Commission of Architectural Review SUBMISSION APPLICATION

13 South 13th Street Submission Application Detailed Description of Proposed Work

Reason: 13 South 13th Street / Richmond

DHR # 2013-242

EXTERIOR ELEVATIONS

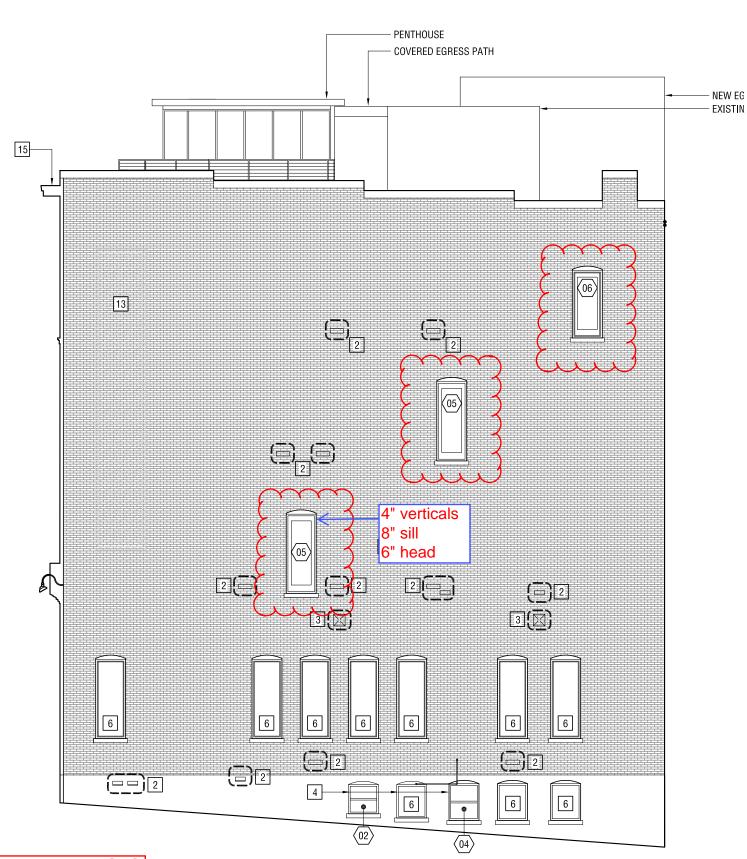
- While modern sash existing on the south and rear elevations can be retained, as proposed, these storefront designs cannot be approved for re-establishing historic window openings. New window openings must be in-filled with new sash matching a documented design, or a compatible contemporary design. (Such as a one over one / double hung sash.) Specifications for the new window sash design should be submitted for review and approval.

ENLARGED PENTHOUSE FLOOR PLAN

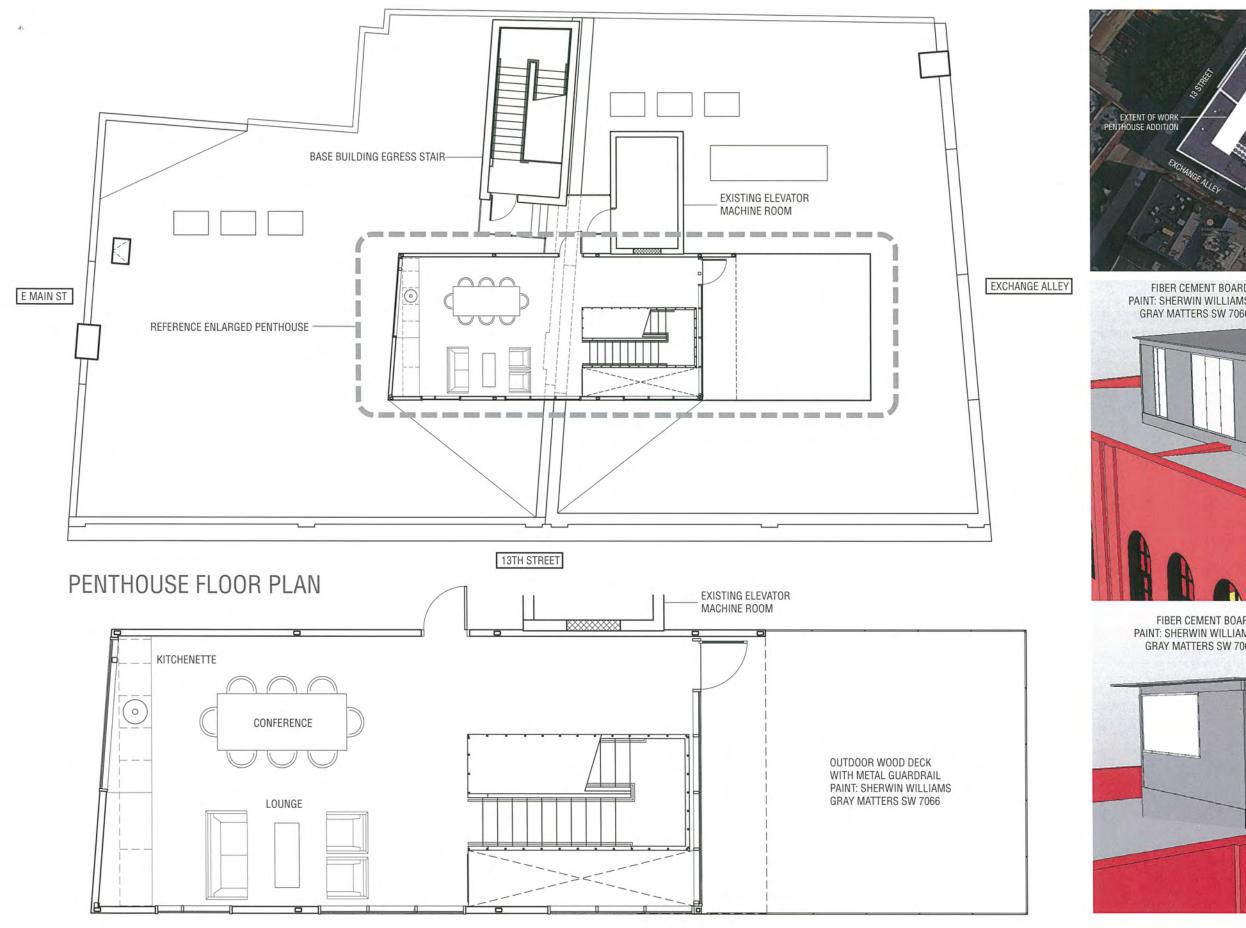
- Typically, rooftop additions on buildings 4 stories (or less) cannot be approved to meet preservation guidelines; constructing additional stories on small scale buildings radically alters the historic appearance of smaller buildings. However, in this case, it appears that the small one story penthouse designed will not be visible for the surrounding historic district. However, should construction of the expanded rooftop penthouse result in a visible rooftop addition, the new construction should be stopped and fully documented and submitted for review. This will ensure that appropriate design changes are made so that an approved Part 3 Certification for the Completed Rehabilitation of your project can be issued.

POWERS - TAYLOR PENTHOUSE ELEVATIONS

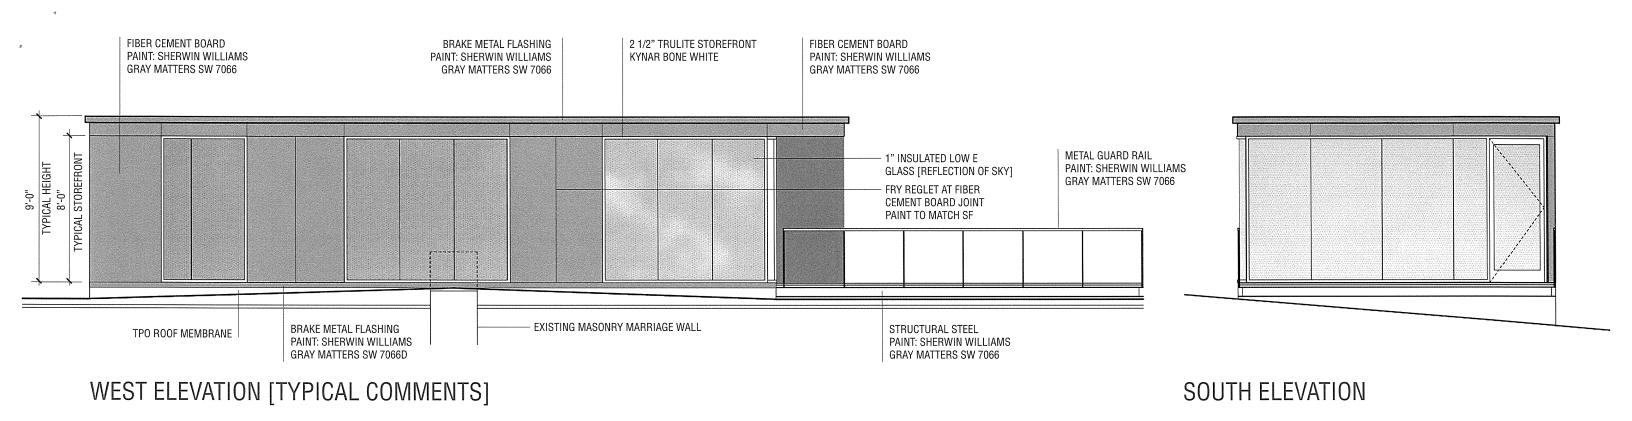
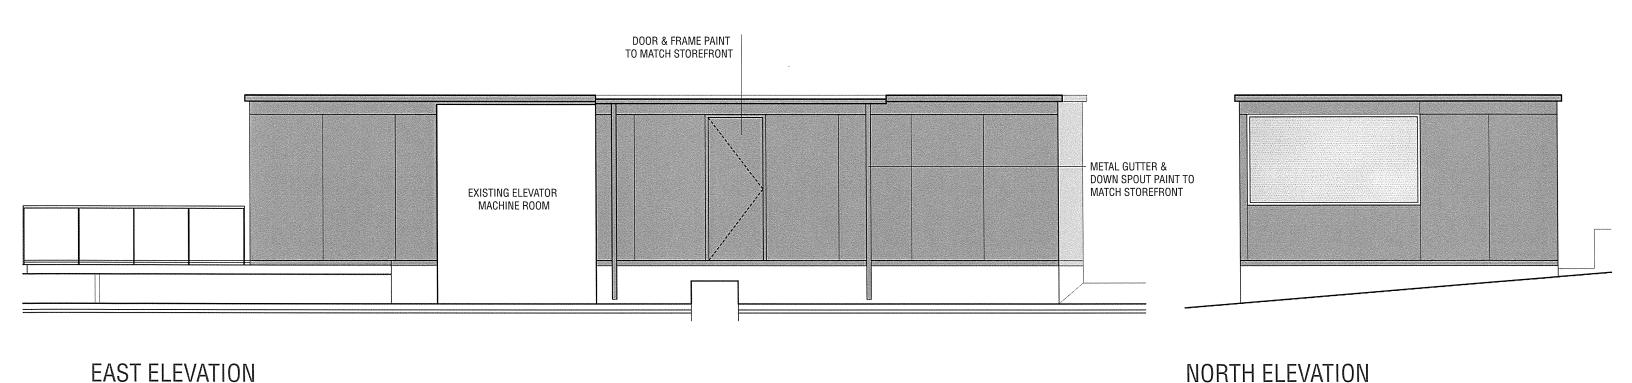
A proposed penthouse is to be constructed tangential to the elevator room. A covered egress path will link the penthouse to the egress stairway. The penthouse is designed to be very simple – a one-story addition with a flat roof and very simple details. The ceiling height on the penthouse will be 8' to minimize visibility. A mock-up of the penthouse, egress stairs, and guard rails demonstrates that the proposed roof top addition will have only minimum visibility. The penthouse is not visible from 13th Street, Cary Street, Shockoe Slip or Main Street, and will only have slight visibility from Exchange Alley which terminates at 13th Street. A small portion of the egress stair will be visible from the rear of the building, when viewing from a small area along Main Street. The proposed penthouse and egress stair are subordinate to the main building and do not detract from the historic character of the building. (See Mock-up photos M1-M20).
